## IV. COMMENT LETTERS AND RESPONSES TO COMMENTS

SUBJECT: Cedars-Sinai Medical Center - West Tower Project - Notice of

**Completion Draft EIR**

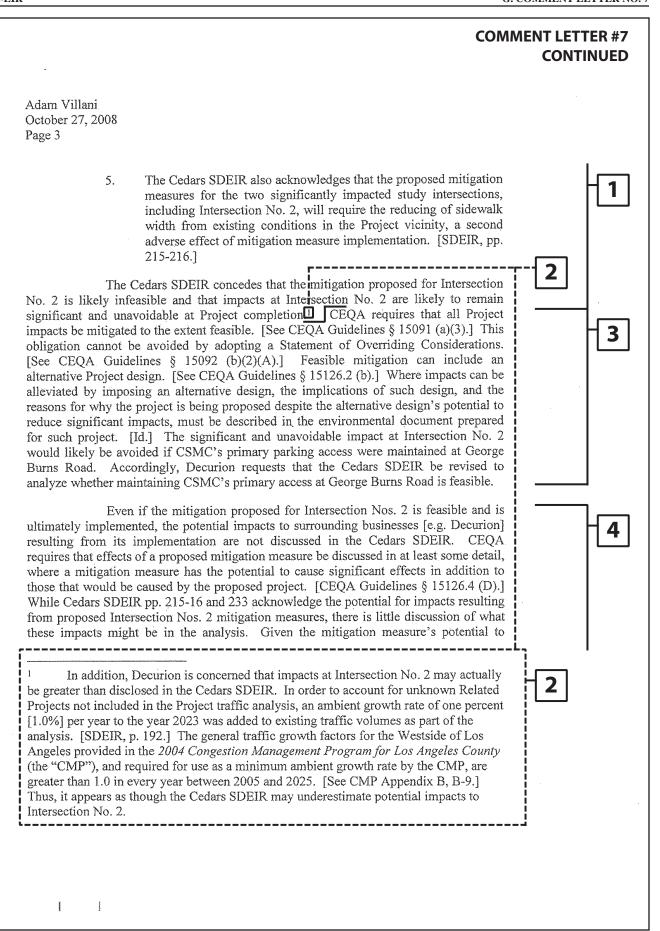
existing parking entrance and truck dock accessed via Alden Drive. Accordingly, Decurion is concerned that the proposed parking entrance at Alden Drive, adjacent to Decurion's own parking, will create unnecessary congestion and parking access/egress obstacles for Decurion's employees and guests, as well as have significant adverse impacts on neighboring office, commercial and retail businesses and their patrons.

- 1. The Project will have significant impacts at Intersection No. 2 during both morning and evening peak hours as demonstrated in Table 26: Summary of Volume-To-Capacity Ratios and Levels of Service utilizing the City's traffic threshold criteria. [SDEIR, p. 212.]
- 2. "As a result, the Project would cause significant impacts for the two intersections [referencing Intersections No. 2 and No. 6]. However, with implementation of mitigation measure improvements, the impacts for both intersections will reduce the potentially significant Project-related impacts to less than significant levels." [SDEIR, p. 212.]

The commentor summarizes factual information excerpted from the Draft SEIR regarding access, level of service, and parking in the vicinity of Robertson Boulevard/Alden Drive-Gracie Allen Drive (Study Intersection No. 2), set forth in *Section IV.D: Transportation and Circulation* (pages 157 to 245) of the Draft SEIR. As presented, the commentor's characterization of the anticipated impact at Intersection No. 2 is essentially correct. The Project access is from Alden Drive-Gracie Allen Drive. Increased trips due to vehicles entering/exiting from this access point due to the Project will reduce the level of service at nearby Intersection No. 2 (Alden Drive-Gracie Allen Drive at Robertson Boulevard) and result in an impact requiring mitigation to reduce the impact to a less than significant level.
